DOE/EIS-0247

# Construction and Operation of the Spallation Neutron Source Facility

## **PUBLIC COMMENTS AND DOE RESPONSES**

## **A. PUBLIC COMMENTS AND DOE RESPONSES**

Figure 4.1.5.2-1. Wetland areas within and adjacent to the proposed SNS site.

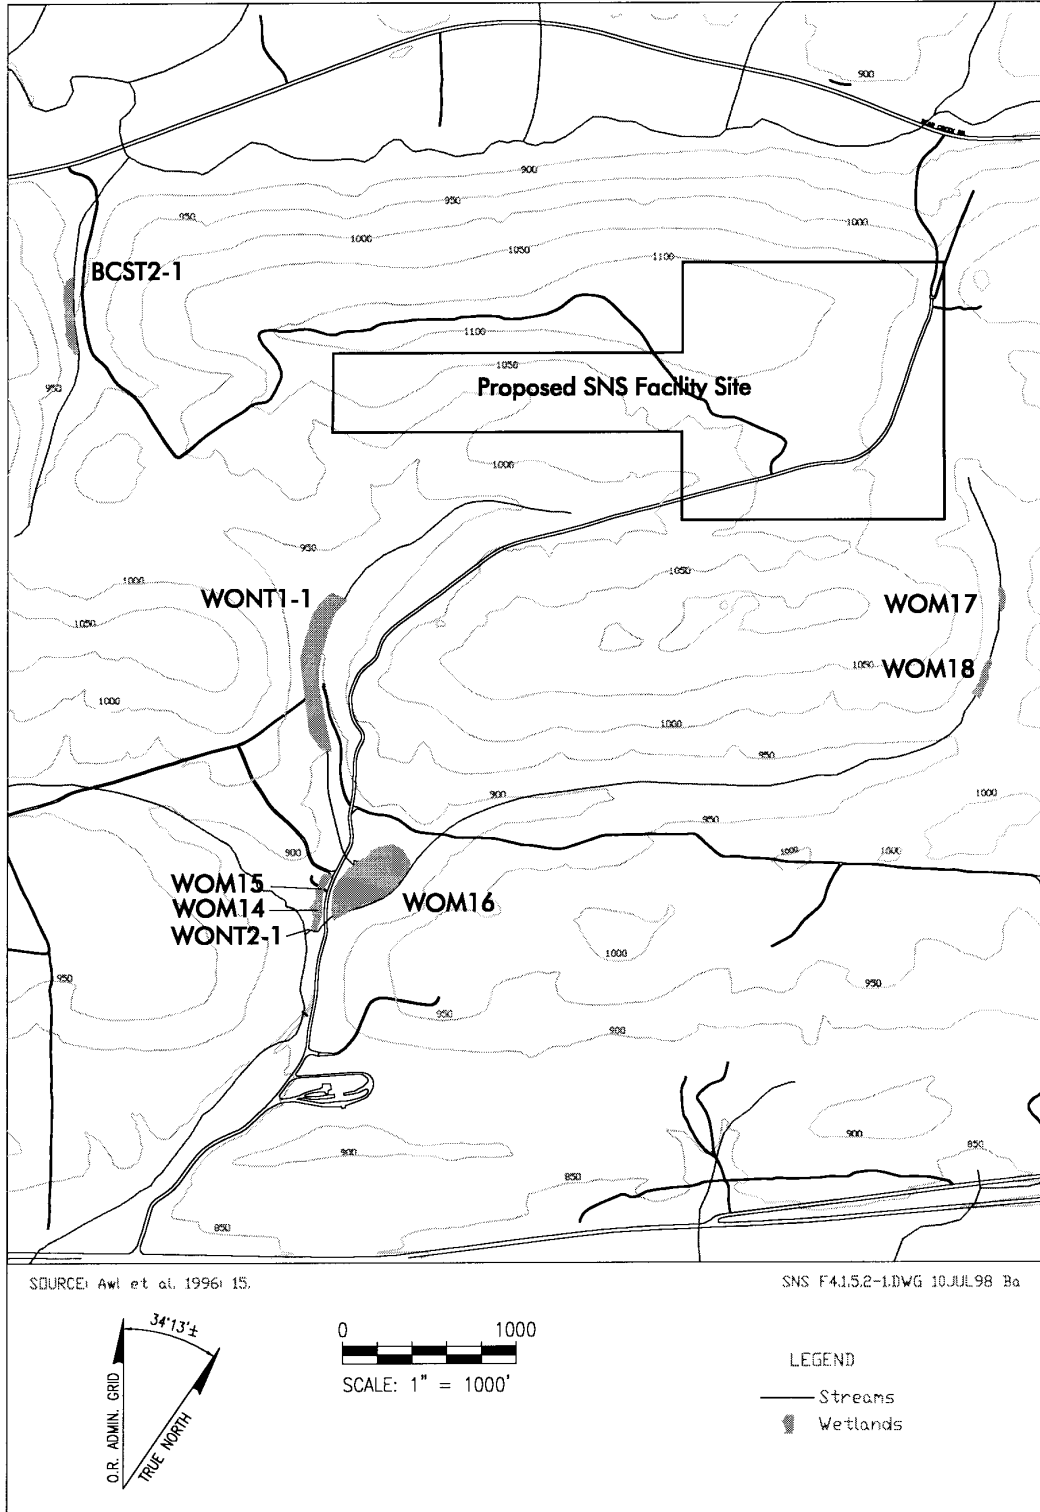
2. Page 4-19 (second paragraph of second column) states that one wetland area near Bear Creek south tributary 4 (BCST4) will be affected. However Table 4.1.5.2-1 and Figure 4.1.5.2-1 show BCST2.

1. Page 4-19 (3rd paragraph) states that one wetland area in the area of BCV south tributary 4 will be affected. However Table 4.1.5.2-1 and Figure 4.1.5.2-1 show BCST2.
2. On page 5-48 in the 2nd paragraph of the 2nd column the annual dose to members of the public, inside and outside the controlled area appear to be reversed.
3. On page 5-38 in the 1st column, 40RE:488 is discussed in both prehistoric and historic resource section, there appears to be an error.
4. On page 4-3 the figure is mislabeled, it should be 4.1.1.1-3 (as referenced on page 4-7). In addition, the four borings discussed should be identified.
5. Figures 1 and 2 in Appendix B are unreadable.

Figure 4.1.5.2-1 on page 4-20 is a representation of the footprint of the proposed SNS at ORNL. Figures 4.1.5.4-1 (page 4-25) and 4.1.5.4-2 (page 4-27) show an outline of the area that was included in the surveillance surveys for protected species. Figures 4.1.5.4-1 and 4.1.5.4-2 have been modified to include the footprint of the proposed facility.
